UNITED STATES PATENT AND TRADEMARK OFFICE

| APPLICATION NO. | FILING DATE | FIRST NAMED INVENTOR | ATTORNEY DOCKET NO. | CONFIRMATION NO. |
|-----------------|-------------|----------------------|---------------------|------------------|
| 10/797,459 | 03/10/2004 | Jeffrey Gilbert | GJE-10102/38 | 4461 |

This Office Action represents a non-final first Office Action for the application titled "LAWN WASTE BAG HOLDER," filed March 10, 2004.

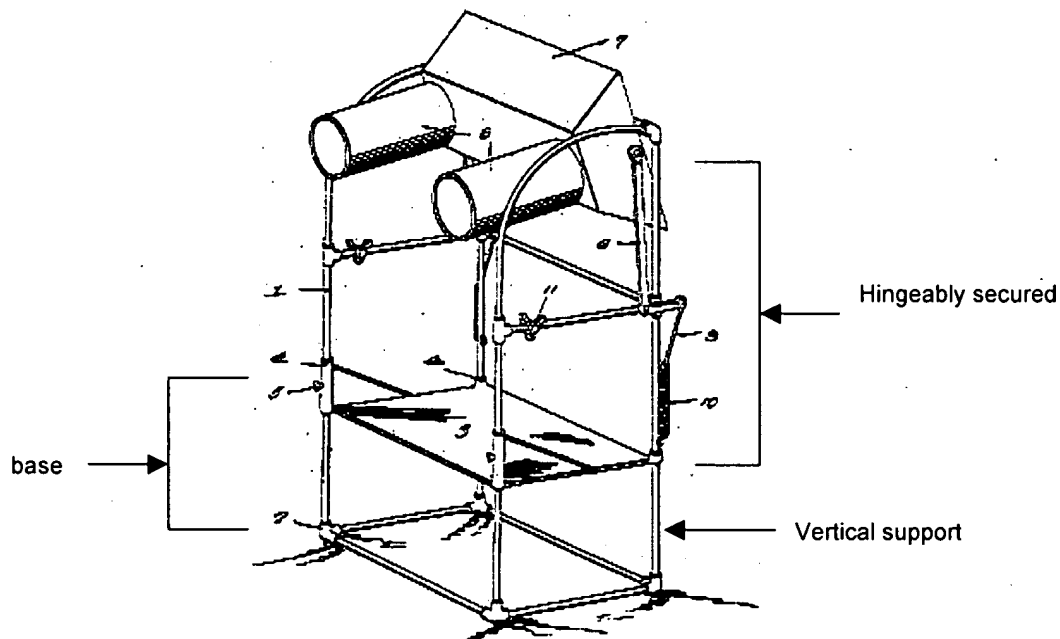
3. Claims 1-3, 7, 9, and 12 are rejected under 35 U.S.C. 102(b) as being anticipated by U.S. Patent No. 1,500,964 to Starks.

Starks discloses a yard waste bag support comprising: a polygonal base (see figure) formed of tubular linear pieces (column 1, lines 35-37) joined by elbow fittings (2) having dimensions to accommodate a yard waste bag therein, a plurality of vertical supports extending from said base to a height to accommodate the yard waste bag (see figure below), and a polygonal funnel (7) of unitary construct hingeably secured (see

figure below) to at least one of said plurality of vertical supports having a mouth greater than the bag opening size.
